Tolerance:	HCdP	Title: HPP1 MK7 Wrong Wiring	
Material:			
Scale: Not to Scale			
Date: Feb 2022	Drw No. HPP1 MK7 WW	Rev. 00	Iss.

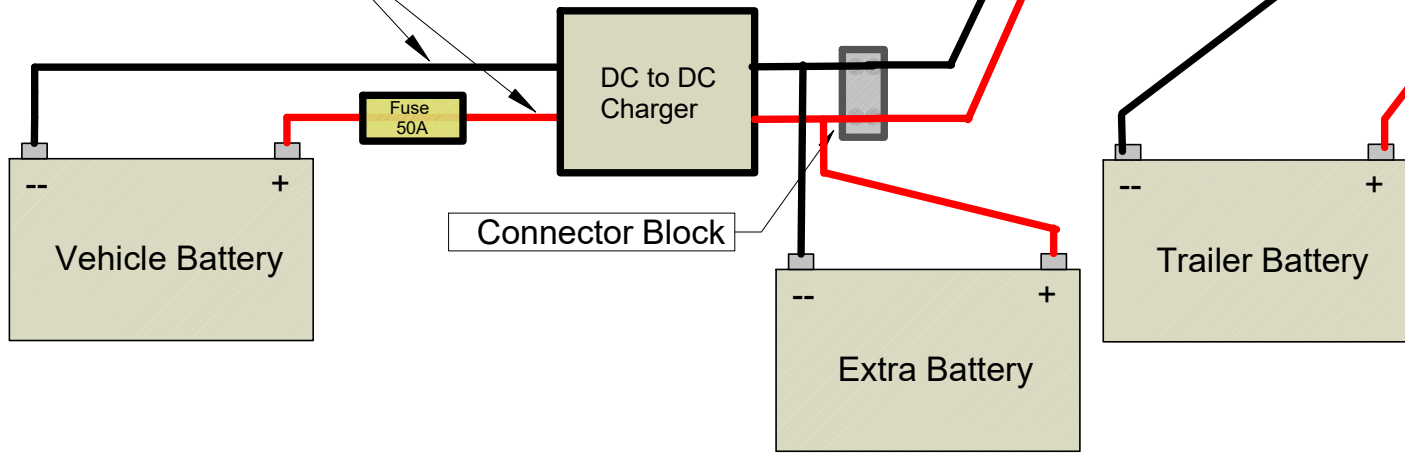
10sqmm multistrand panel wire
Maximum current = 30A

Incorrect wiring - DC to DC charger cannot supply current demand of HPP1 MK7
